ADDENDUM NUMBER 1

UPGRADE MER DATA CENTER AT CJF

Project Number: O221-11441

Date of Addendum: December 20, 2011

ADDENDUM DRAWING (A100)
SDA-001

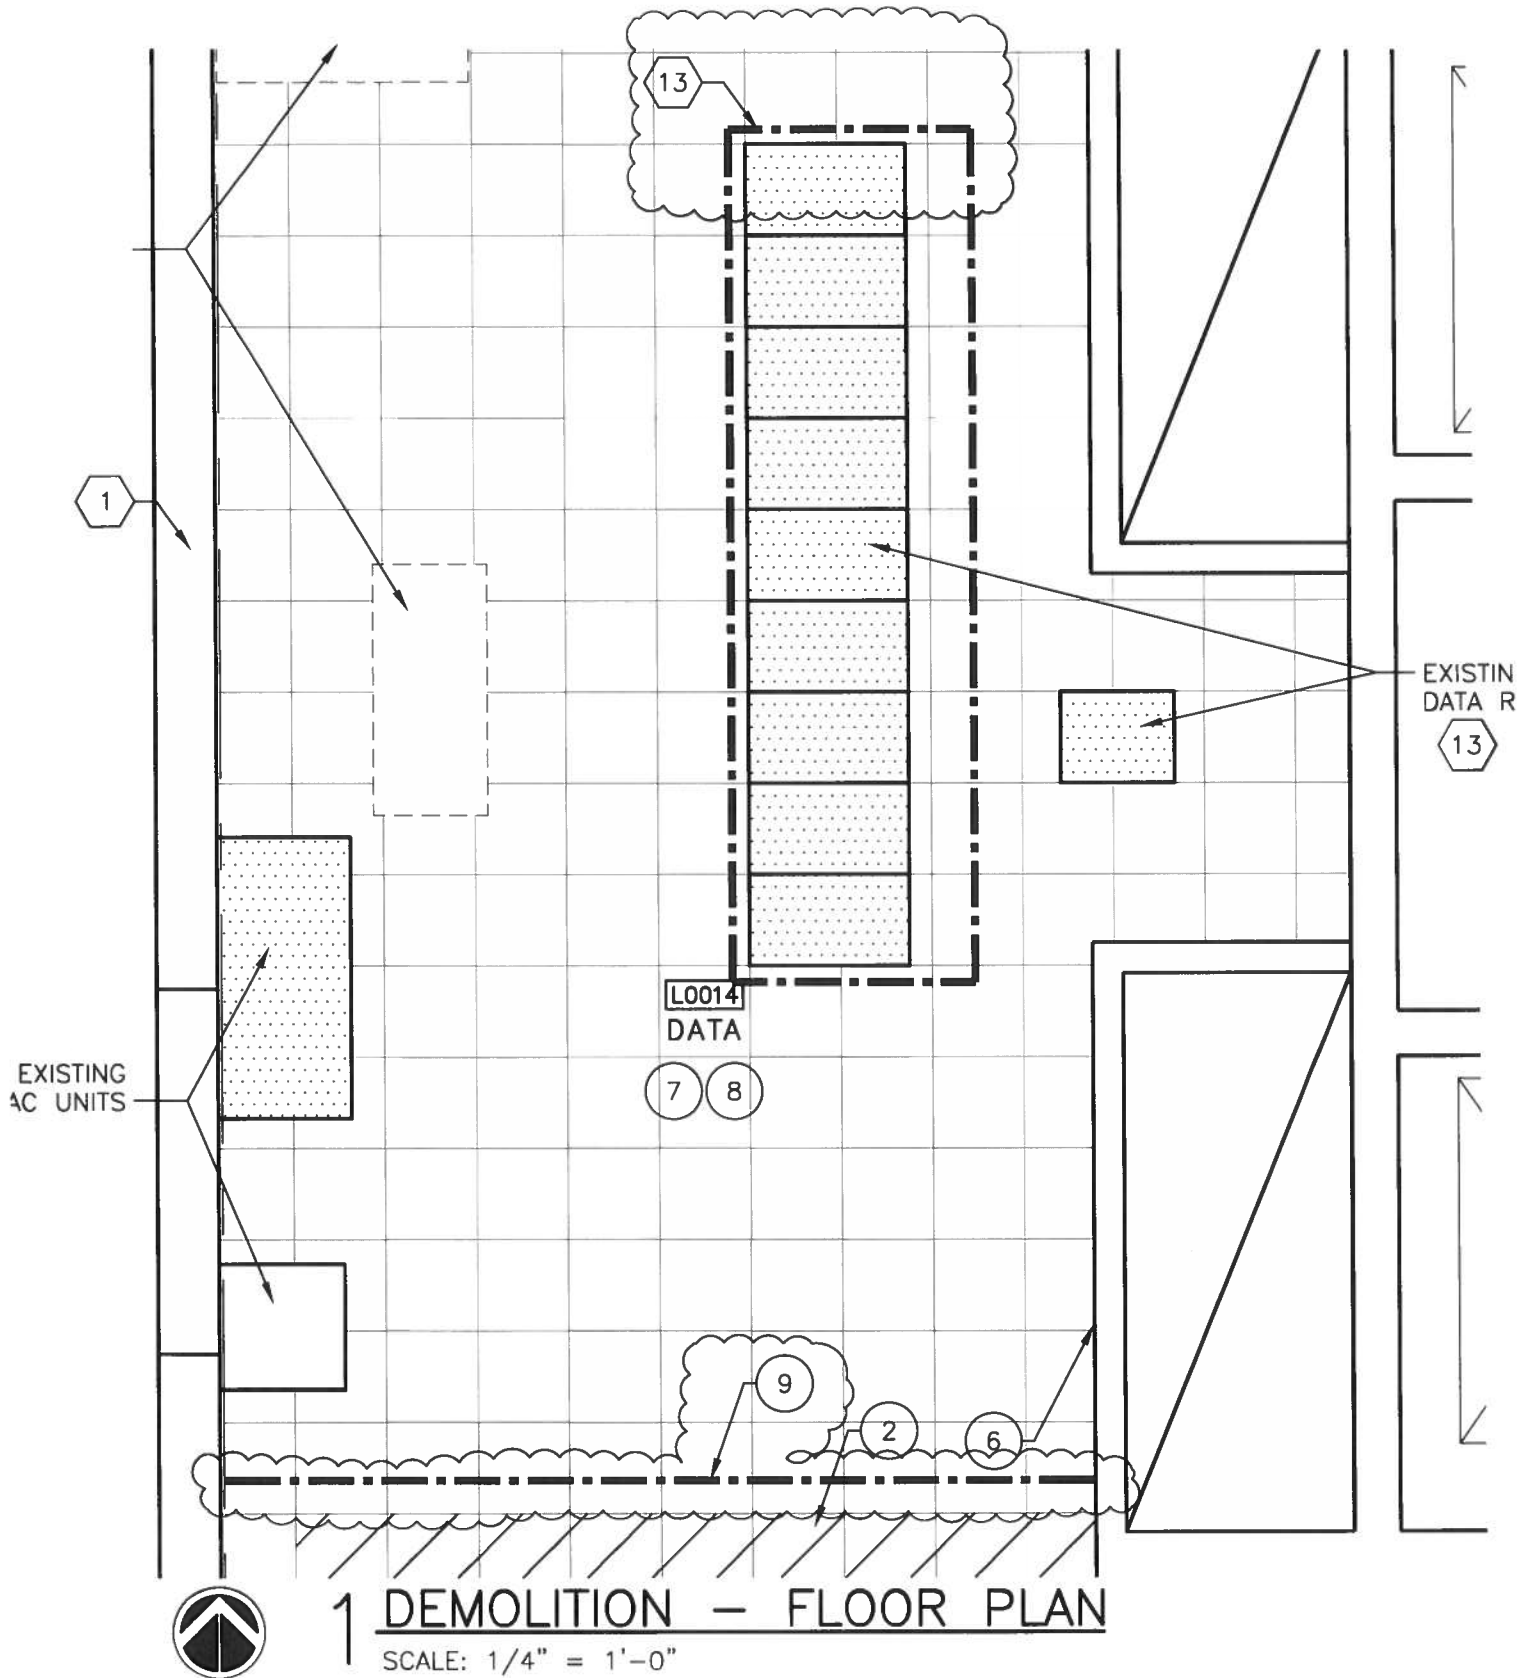
1. Sheet A100 Demolition Key Notes
ADD Note #9 as follows;
#9. Construction dustproof containment partition. Provide sealed door opening as required for access into the data room. Data room & equipment operational throughout construction.

2. Sheet A100 Demolition Plan ADD Changes to plan as indicated on supplemental detail SDA-001 attached. Changes include dustproof partition location & contractor requirements to protect & maintain existing equipment during construction.
